TECHNICAL MEMORANDUM (UPDATED 3.2.23)

Review of Stormwater Management System (Hydraulic Assessment)

Optimal Stormwater has completed an independent review and hydraulic analysis of the existing and proposed stormwater system at Norman Griffiths Oval.

Figure 1. Existing Pit Showing Peak Flow Locations

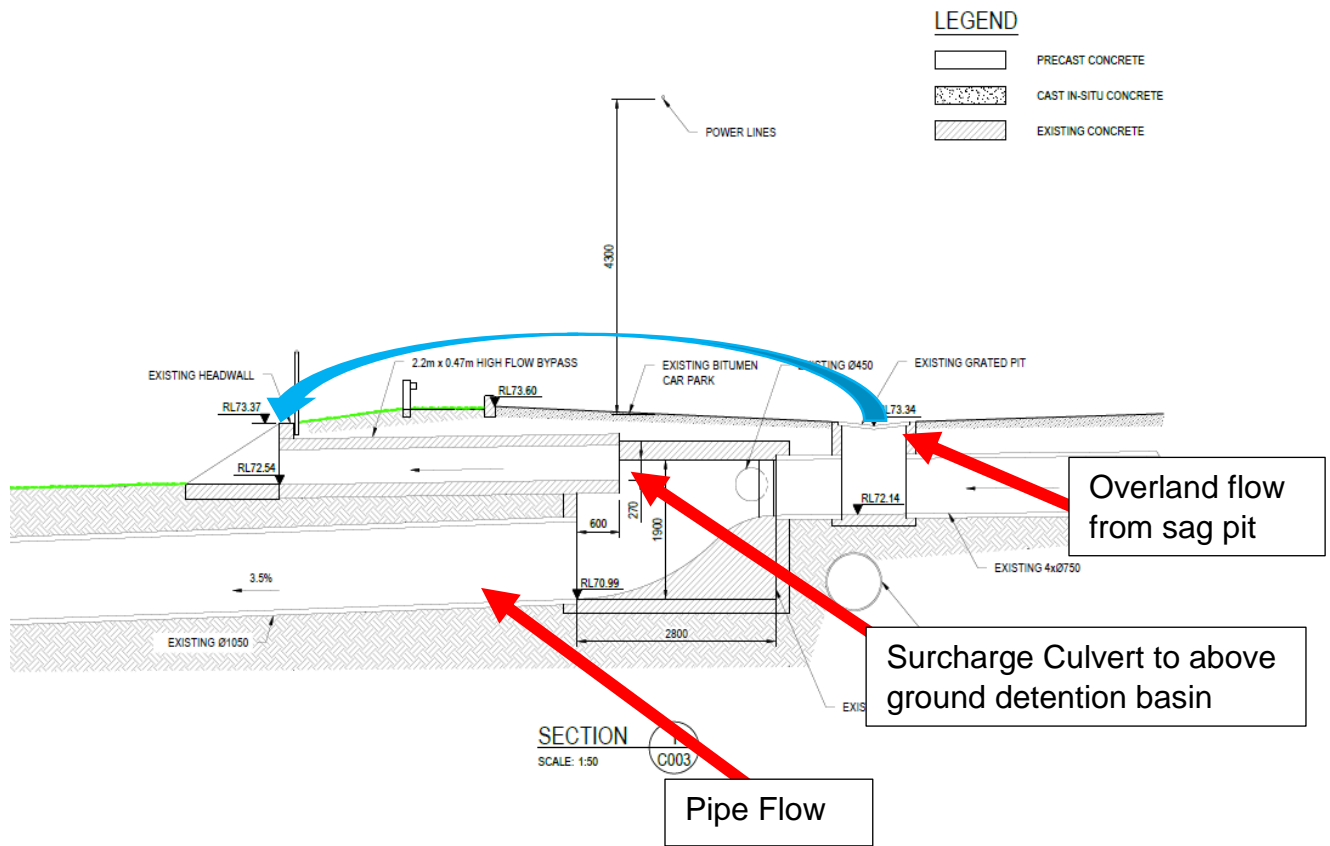
Based on the DRAINS model for the existing stormwater system at Norman Griffiths Oval, the piped system can convey the 10-year storm event. The above-ground OSD manages flows exceeding the 10-year storm event.

Figure 4. Proposed Pit Showing Peak Flow Locations

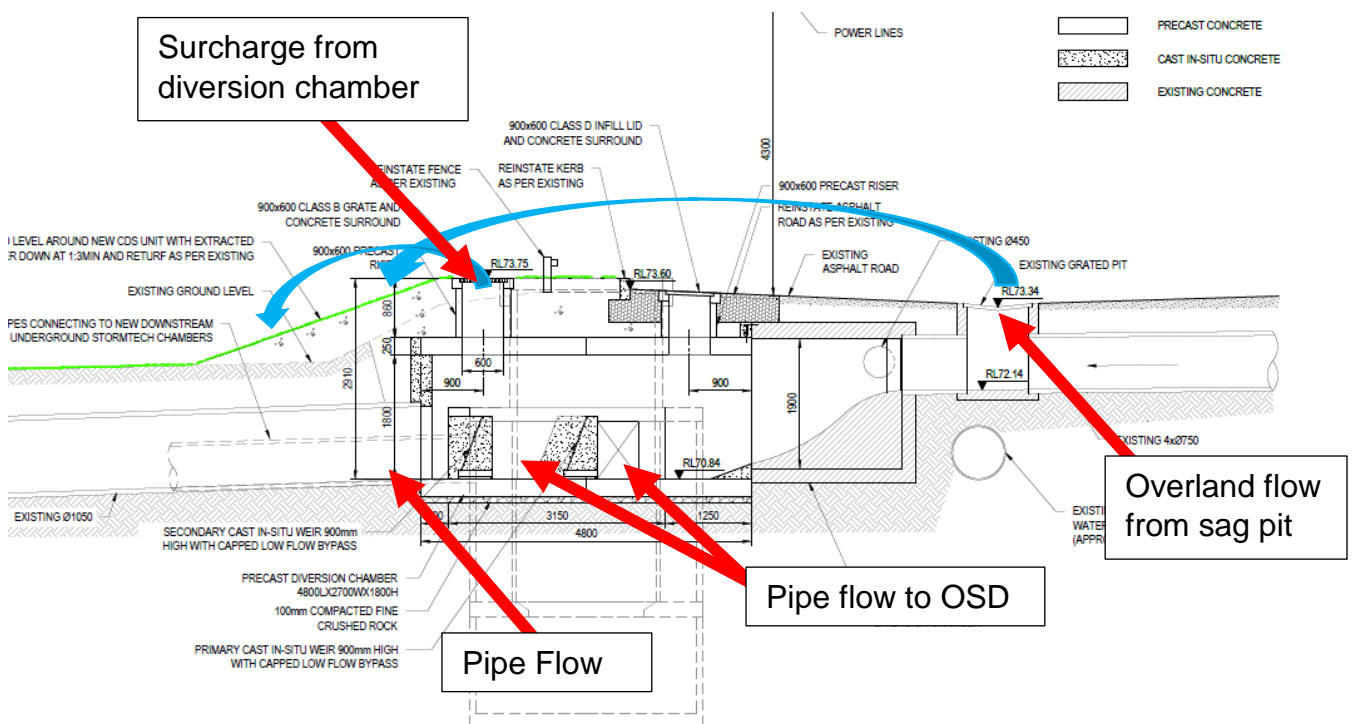
Based on the DRAINS model for the proposed stormwater system at Norman Griffiths Oval, the piped system can convey up to the 10-year storm event.

Figure 5. Downstream Grate and Overland Flow Path Location

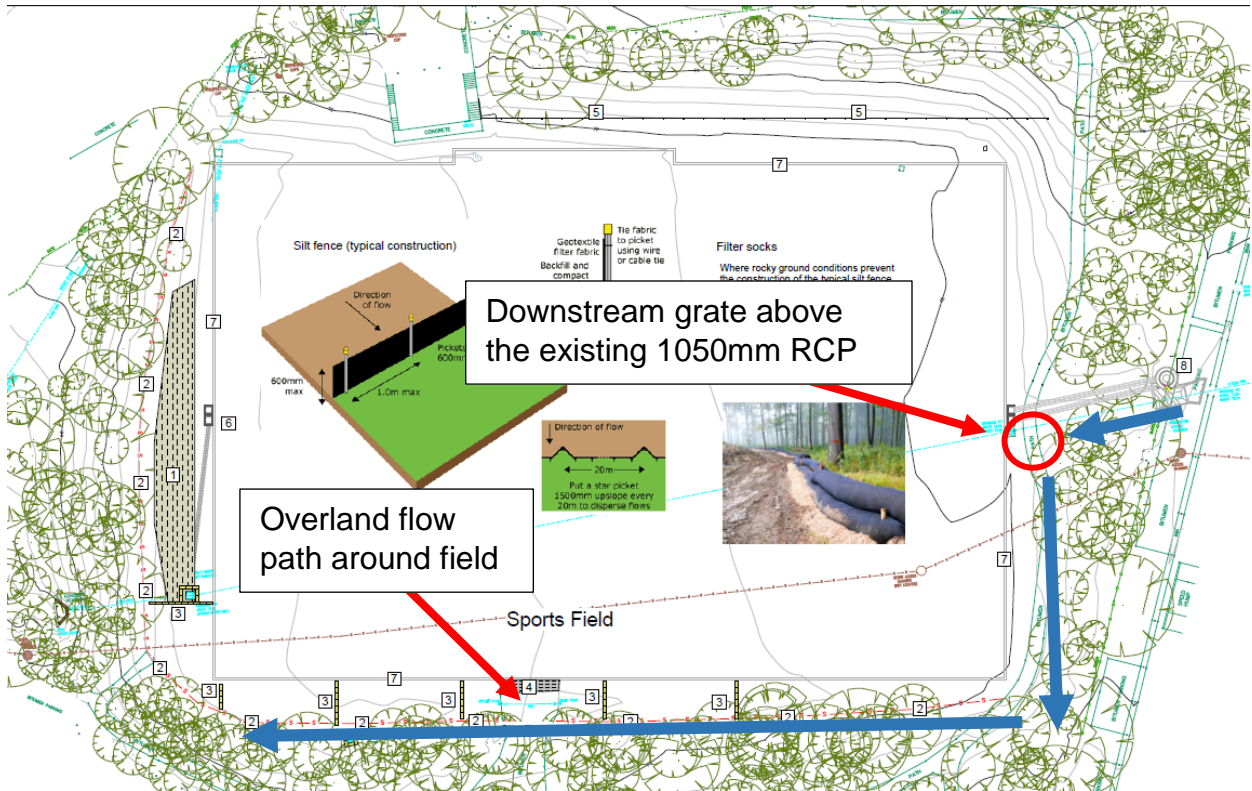
In larger storm events, excess flow is collected by the downstream grate above the existing 1050mm RCP. Once the downstream grate or 1050mm RCP is at capacity, flow is conveyed along the overland flow path around the oval to Quarry Creek. Refer to figure 5 below.

In the 20-year and 100-year storm events, the peak flow rate conveyed by the overland flow path around the field is 0.002m³/s and 0.18m³/s. In the 100-year event, the expected depth x velocity is 0.06m²/s and is considered safe and does not require turf reinforcement (ARR 2019).

Figure 9. Water level in underground OSD – 100-year event

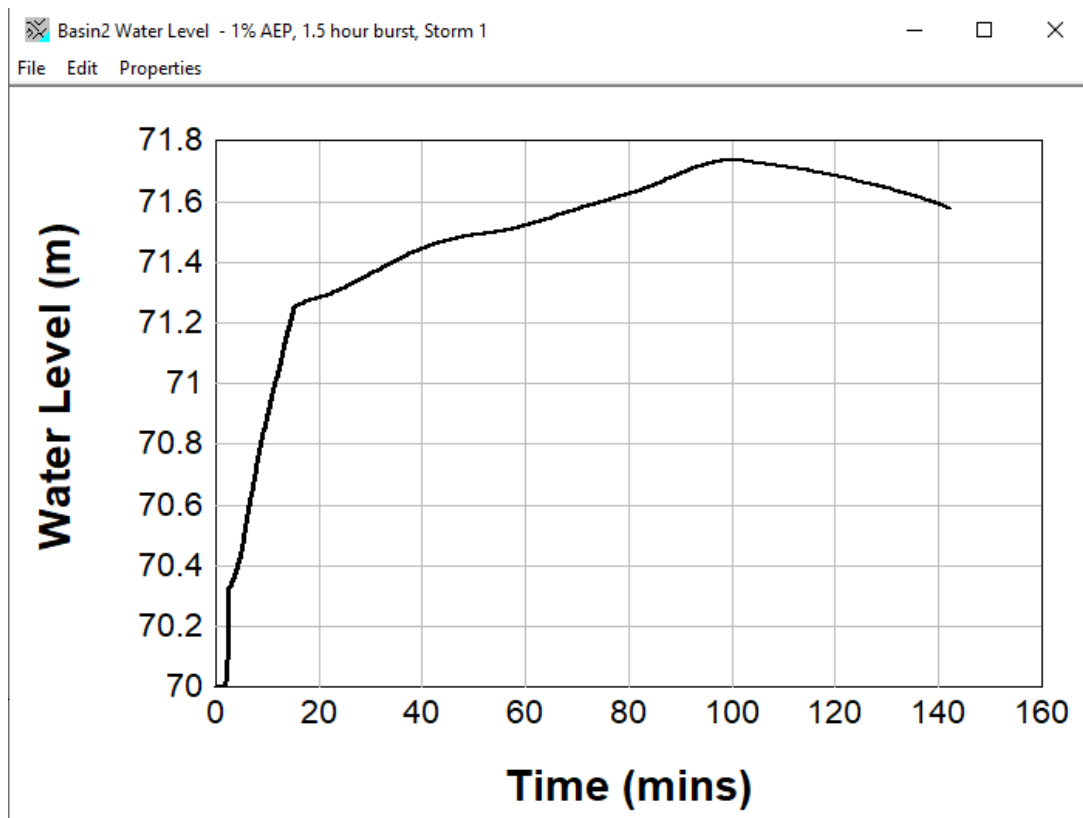
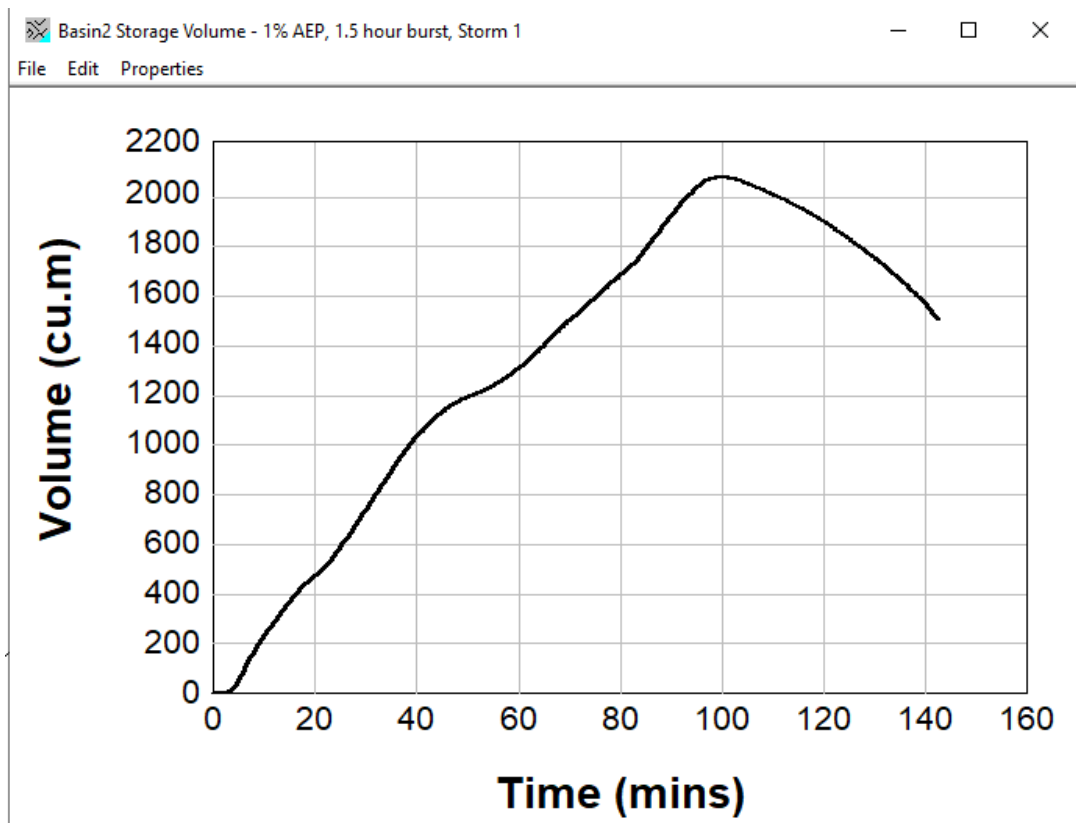
DRAINS modelling of the proposed underground OSD confirms the capacity is adequate to detain the 100-year storm event. The underground OSD reaches ~90% maximum capacity (2.4ML) in the 100-year event. As the OSD exceeds 100% capacity, the 2x 1200x100mm overflow culverts convey excess flow.
